TWELVE MILE CROSSING AT FOUNTAIN WALK NEW RETAIL BUILDING SP 12-26

12 MILE CROSSING AT FOUNTAIN WALK – NEW RETAIL BUILDING SP12-26

PLANNING REVIEW

ENGINEERING REVIEW

PHASING PLAN

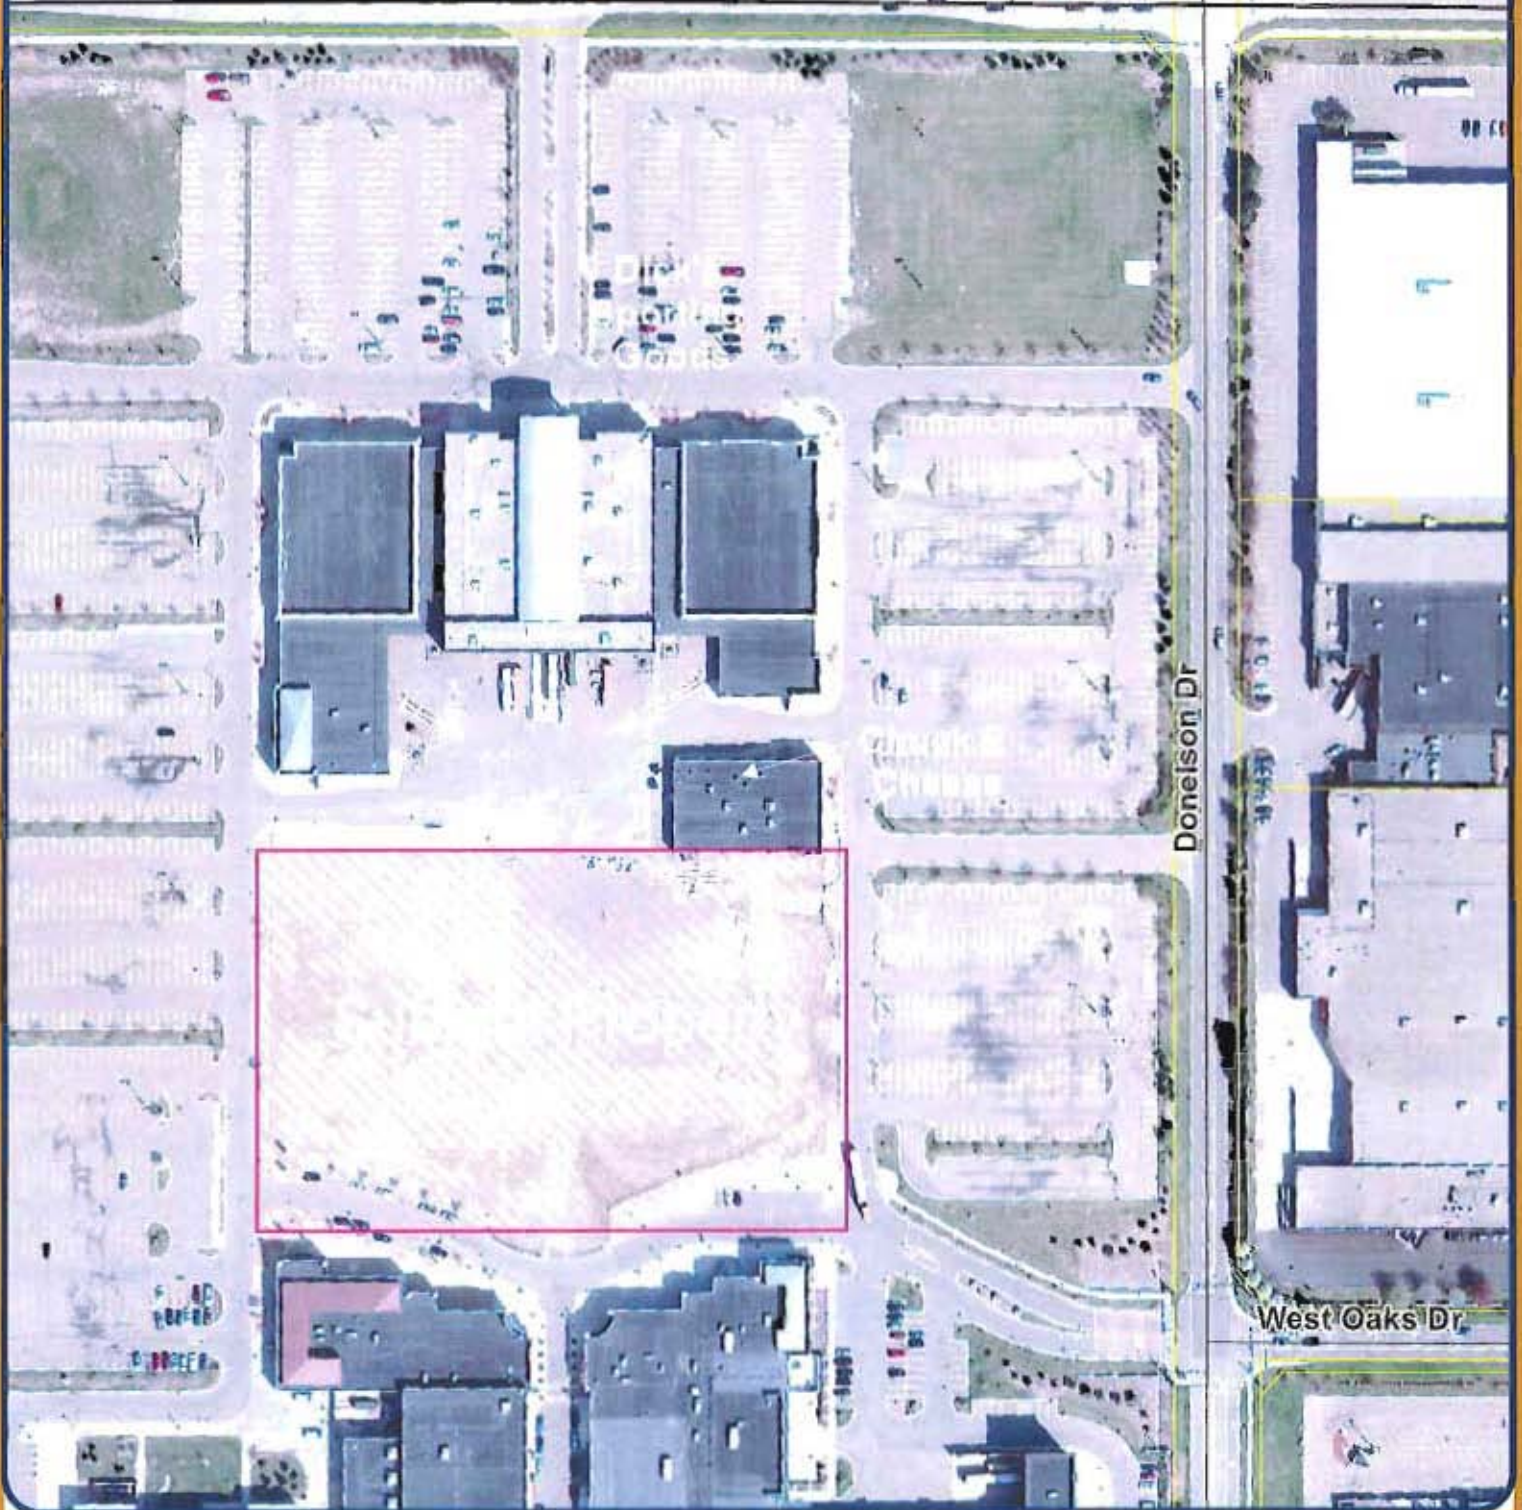
- a. All facades of the anchor tenant building identified as Phase 2 must meet the standards of the façade ordinance or any waivers that are granted. The applicant must provide a note on the plans to indicate compliance with this condition;

- b. The area identified for Phases 2 and 3 shall be maintained as landscaped greenspace until construction on the respective phases begins;
- c. A portion of the pathway totaling at least 5' width and included in Phases 2 and 3 along the proposed building frontages shall be installed with the construction of Phase 1;

- d. Loading zone screening consisting of landscape materials approved by staff shall be installed along the south side of the existing loading zone in the area where Phases 2 and 3 are currently shown within one year of the completion of Phase 1 if construction on Phases 2 and 3 has not begun;
